Contract #: 04-0120F4Cty: SF/ALA Rte: 80 PM: 13.2/13.9File #: 69.25B**QUALITY ASSURANCE -- NON-CONFORMANCE REPORT****Location:** Changxing Island, Shanghai, P.R. China**Report No:** NCR-000689**Prime Contractor:** American Bridge/Fluor Enterprises, a JV**Date:** 27-Feb-2010**Submitting Contractor:** Zhenhua Port Machinery Company, Ltd (ZPMC), Changxing Island**NCR #:** ZPMC-0656**Type of problem:**

**Reference Description:** Missed MT Transverse Indications by QC on the LD to FB weld splice on Segment 6BE

<b>To:</b>	AMERICAN BRIDGE/FLUOR, A JV 375 BURMA ROAD OAKLAND CA 95607	<b>Date:</b>	01-Feb-2010
<b>Dear:</b>	Mr. Charles Kanapicki	<b>Contract No:</b>	04-0120F4 04-SF-80-13.2 / 13.9
<b>Attention:</b>	Mr. Thomas Nilsson Project/Fabrication Manager	<b>Job Name:</b>	SAS Superstructure
<b>Subject:</b>	NCR No. ZPMC-0656	<b>Document No:</b>	05.03.06-000646

Contract #: 04-0120F4Cty: SF/ALA Rte: 80 PM: 13.2/13.9File #: xx.25A**QUALITY ASSURANCE -- NON-CONFORMANCE RESOLUTION****Location:** Changxing Island, Shanghai, P.R. China**Report No:** NCS-000585**Prime Contractor:** American Bridge/Fluor Enterprises, a JV**Date:** 15-Apr-2010**Submitting Contractor:** Zhenhua Port Machinery Compa

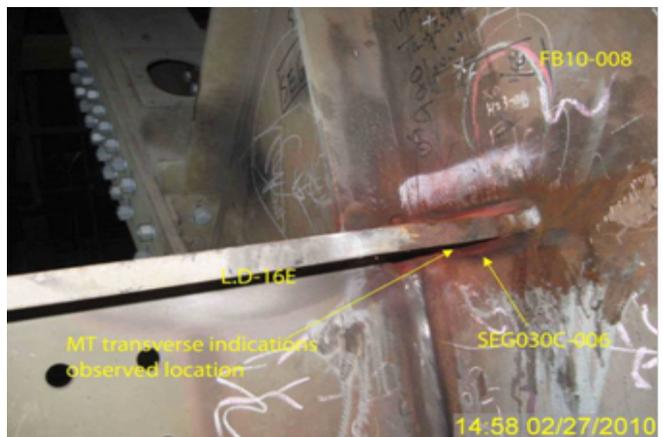
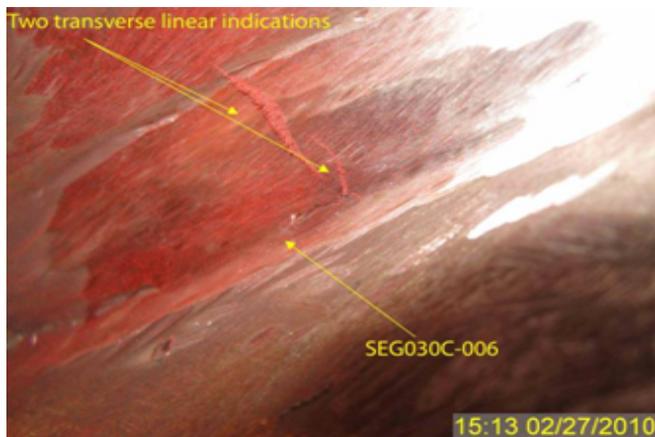
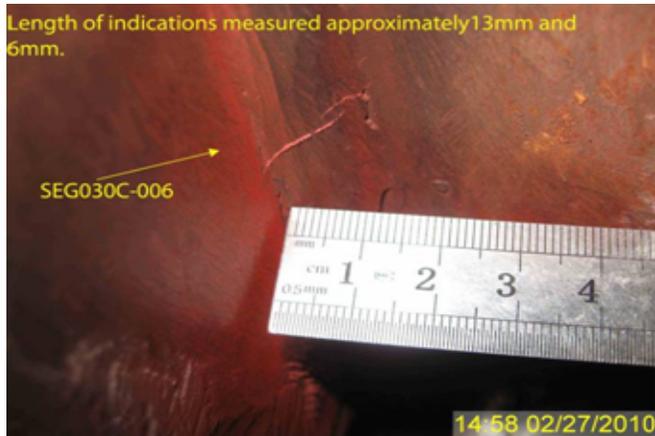
During the Quality Assurance (QA) Magnetic Particle (MT) testing review of welds located on OBG Segment 6BE, this QA Inspector discovered the following issue:

- Two (2) Transverse linear indications in the Longitudinal Diaphragm 16E flange (X42M), CJP attachment to panel point 41 Floor Beam web (X47B).
- The indications are located at Y locations 110 and 115 respectively when measures from the leading edge of the flange.
- The weld designation is SEG030C-006
- The transverse indications are clearly marked on the weld.
- Length of indications measured approximately 13mm and 6mm.
- The weld was previously cut apart and re-welded due to issues with fit up.
- The OBG segment 6BE is located in the trail assembly.
- The Notice of Witness Inspection Number (NWIT) is 005237. The indication is located inside the area that has been previously tested and accepted by ZPMC Quality Control (QC) personnel. As per the contract documents, ZPMC QC personnel are required to perform 100% Magnetic particle inspection of these welds.

Special Provisions Section 8.3 – “Quality Control (QC) shall be the responsibility of the Contractor. As a minimum, the Contractor shall perform inspection and testing of each weld joint prior to welding, during welding, and after welding as specified in this section and to ensure that materials and workmanship conform to the requirements of the contract documents.”

AWS D1.5 (02) Section 6.26.2 – “Welds that are subject to MT in addition to visual inspection shall have no cracks.

Propose a resolution for the identified non-conformance with revised procedures to prevent future occurrences and repair the indications per contract requirements and submit required repair documentation including passing NDT for the Engineer's review. A response for the resolution of this issue is expected within 7 days.

ZPMC has repaired the missed indication and is providing NDT documentation to show that it is acceptable. ZPMC has conducted training with its inspectors to reduce these types of incidents and there has been a decrease in since the training has occurred. Based on this ZPMC requests closure of this NCR.

This proposed resolution is acceptable. The documentation received is sufficient and the Department concurs that Non-Conformance ZPMC-0656 is closed.

Reference Description: Missed MT Transverse Indications by QC on the LD to FB weld splice on Segment 6BE

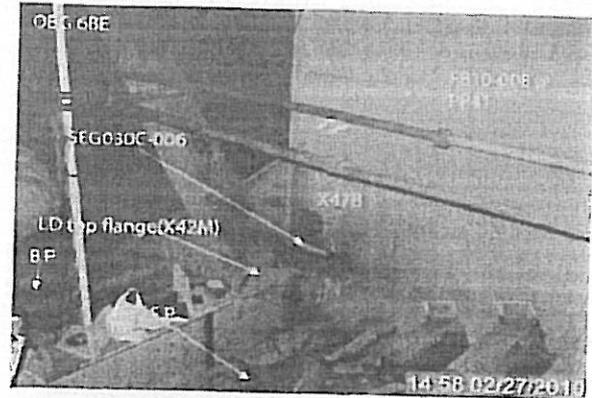
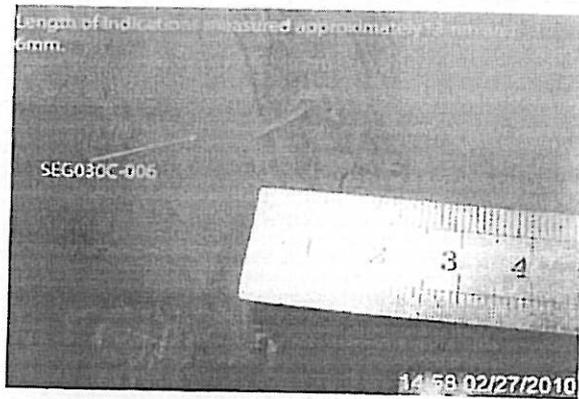
During the Quality Assurance (QA) Magnetic Particle (MT) testing review of welds located on OBG Segment 6BE, this QA Inspector discovered the following issue:

- Two (2) Transverse linear indications in the Longitudinal Diaphragm 16E flange (X42M), CJP attachment to panel point 41 Floor Beam web (X47B).
- The indications are located at Y locations 110 and 115 respectively when measures from the leading edge of the flange.
- The weld designation is SEG030C-006
- The transverse indications are clearly marked on the weld.
- Length of indications measured approximately 13mm and 6mm.
- The weld was previously cut apart and re-welded due to issues with fit up.
- The OBG segment 6BE is located in the trail assembly.
- The Notice of Witness Inspection Number (NWIT) is 005237. The indication is located inside the area that has been previously tested and accepted by ZPMC Quality Control (QC) personnel. As per the contract documents, ZPMC QC personnel are required to perform 100% Magnetic particle inspection of these welds.

Special Provisions Section 8.3 – “Quality Control (QC) shall be the responsibility of the Contractor. As a minimum, the Contractor shall perform inspection and testing of each weld joint prior to welding, during welding, and after welding as specified in this section and to ensure that materials and workmanship conform to the requirements of the contract documents.”

AWS D1.5 (02) Section 6.26.2 – “Welds that are subject to MT in addition to visual inspection shall have no cracks.

Repair said indications and perform NDT required to verify weld quality.

Contractor supplied post repair NDT reports verifying welds are now in conformance with Contract specifications.
